#### 924-2010 ADDENDUM 2

REQUEEST FOR PROPOSAL FOR AN OWNER ADVOCATE/PROJECT MANAGER FOR A TRANSIT BUS PARKING AND SERVICING GARAGE DESIGN-BUILD PROJECT

Add: Site of Proposed Garage

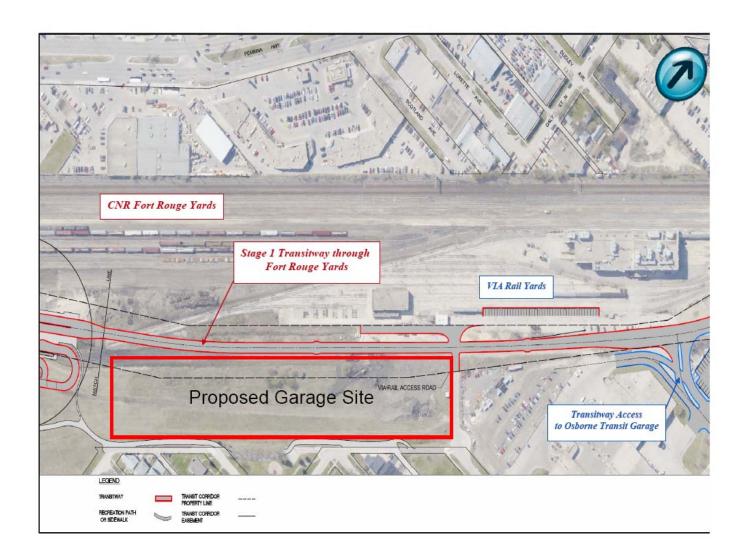
19	Does the City own the property?	Yes.
20	Is there any information on the existing services near the site?	Limited information exists. The property has a water main and gas main that may have to be moved depending on the location of the

building. A land drainage sewer has been installed on west side of the site to accommodate the first stage of the South West Rapid Transit Corridor.
21	What is driving the schedule?	Transit is at its capacity in the two existing garages and additional space is required.
22	Are there any previous reports for the proposed Transit Bus Parking and Service Garage?	No.
23	Are there any previous environmental investigations for the proposed site (i.e. a Phase 1 or Phase 2 environmental assessment)?	No.
24	Is a legal survey available for the site to define property lines?	No.
25	Are there any other reports or information available for the site, such as topographical surveys, traffic studies, zoning investigations, site layouts, etc?	No.
26	Is there a geotechnical study available for the Transit Corridor adjacent the site?	No
27	In our fee for this section, are we to include the costs of procuring such items as the environmental impact study, geotechnical survey and conceptual design etc., or is our fee only to include the management, procurement and overseeing such items?	Yes, fees must include the costs of procuring the environmental impact study, geotechnical survey, conceptual design, etc.
